STATE OF NORTH CAROLINA
DEPARTMENT OF TRANSPORTATION

Subject: DCM Consistency for the proposed US 70 Havelock Bypass in Craven County. TIP No. R-1015. WBS 34360.1.2.

The North Carolina Department of Transportation (NCDOT) submitted additional information on Havelock Bypass to you on March 13, 2020 for review in regards to the Division of Coastal Management's CAMA Consistency Determination for the project. This package included supplemental information and revised permit drawings. Based on further coordination with the NC Division of Water Resources, further revisions need to be made to this request. This letter is a revised version of the March 13, 2020 request, showing additional and modified information highlighted in red.

PERMIT DRAWING
SHEET 148 OF 167

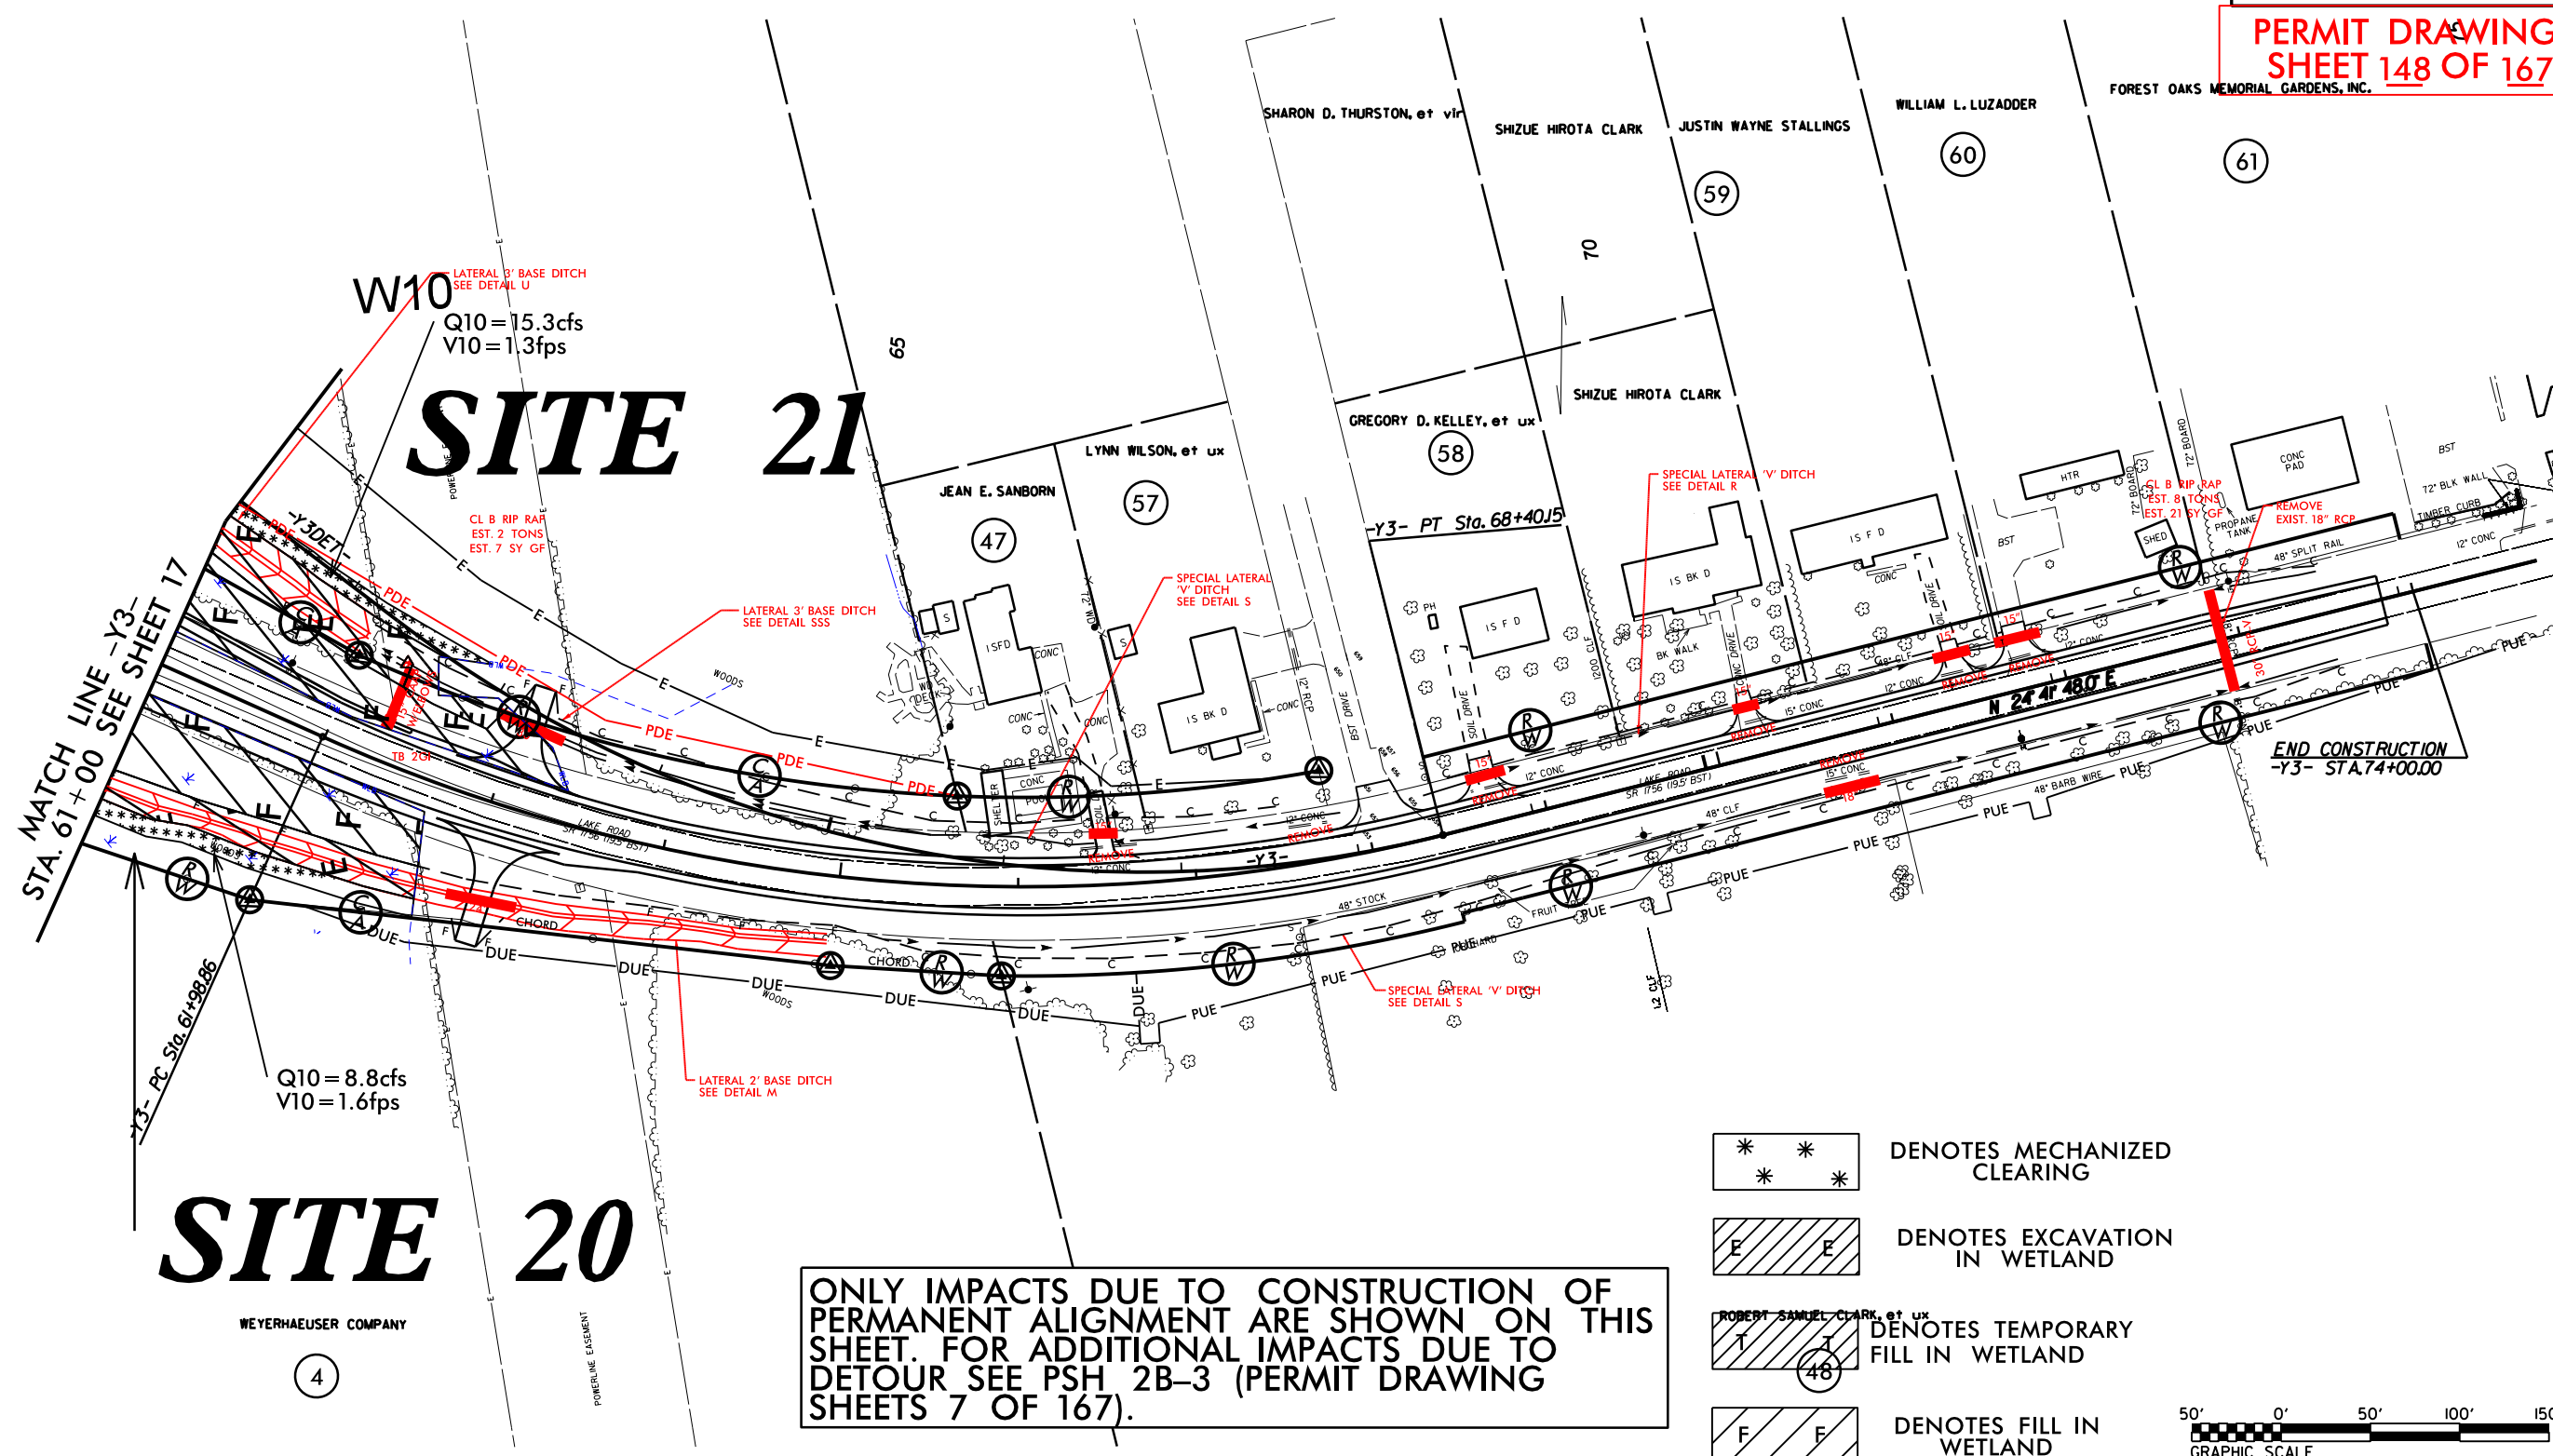
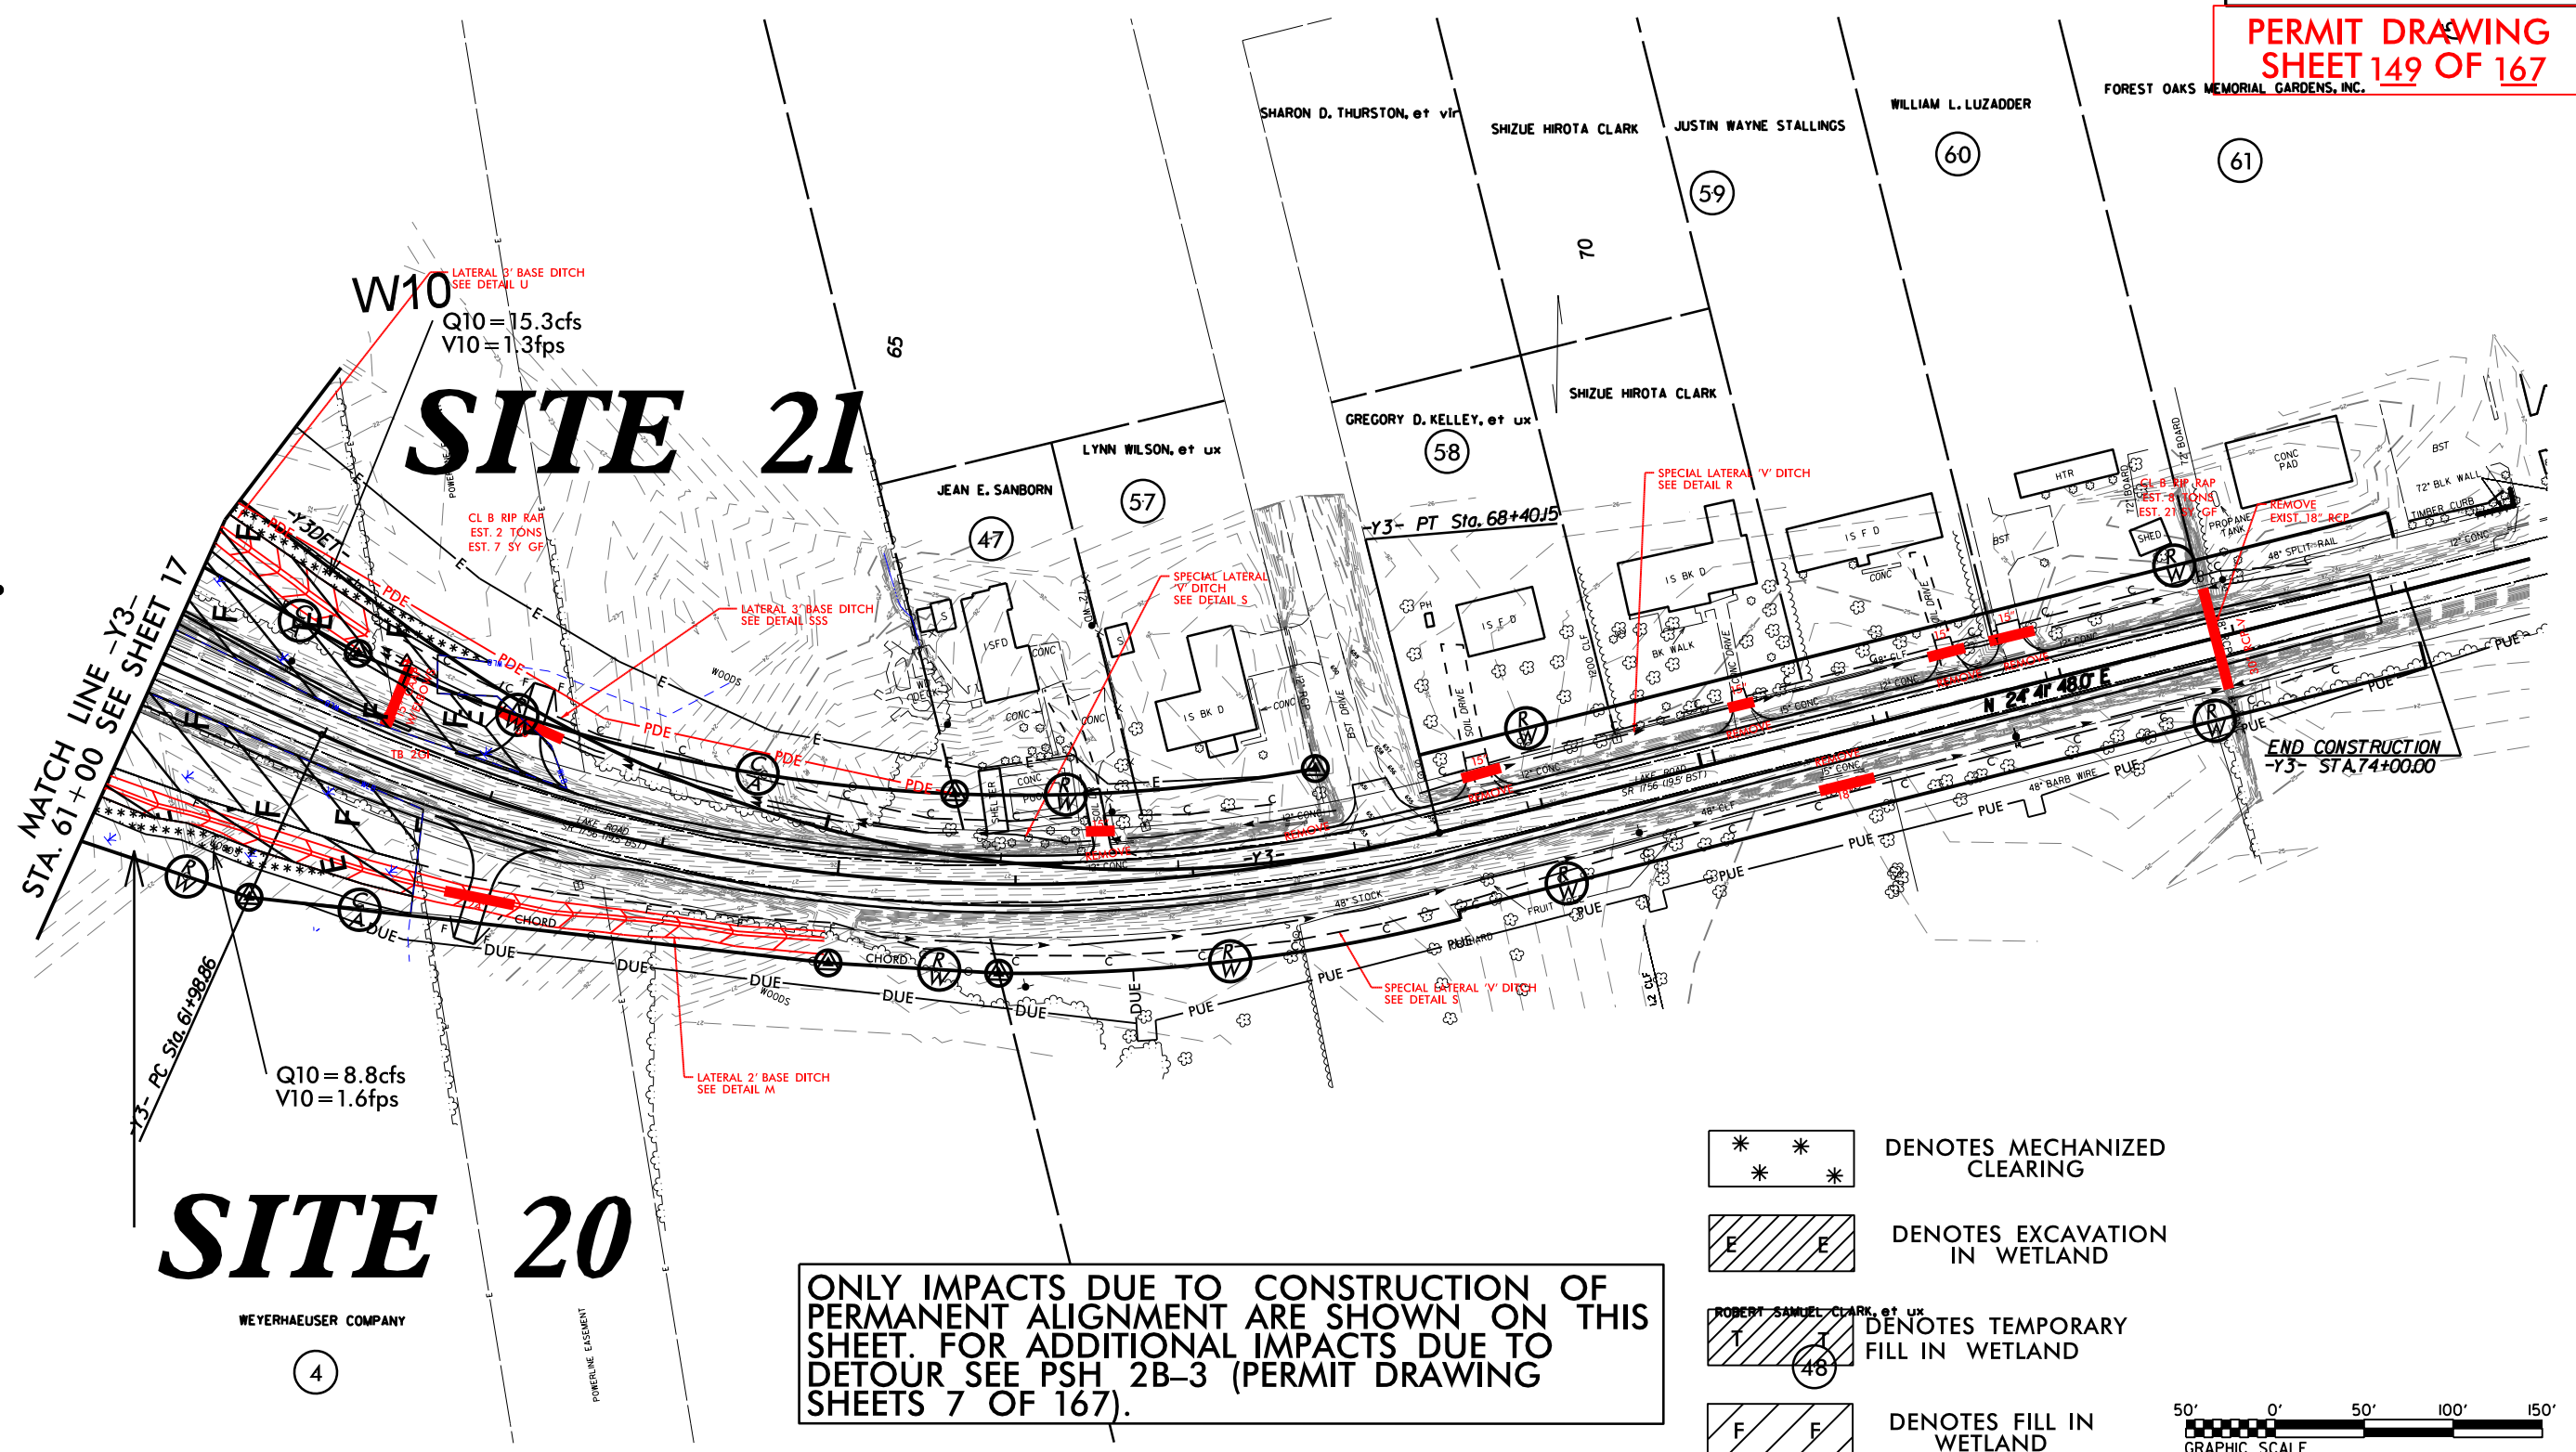
- Update to permit sheets 124 & 125. Changes were outside of impacted areas
- Update to permit sheets 130 & 131. Changes were outside of impacted areas
- Site 21 (permit sheets 148 &149) pipe outlet shifted, fill increased, excavation decreased, no change to total impacts permitted for site (0.85 acre).
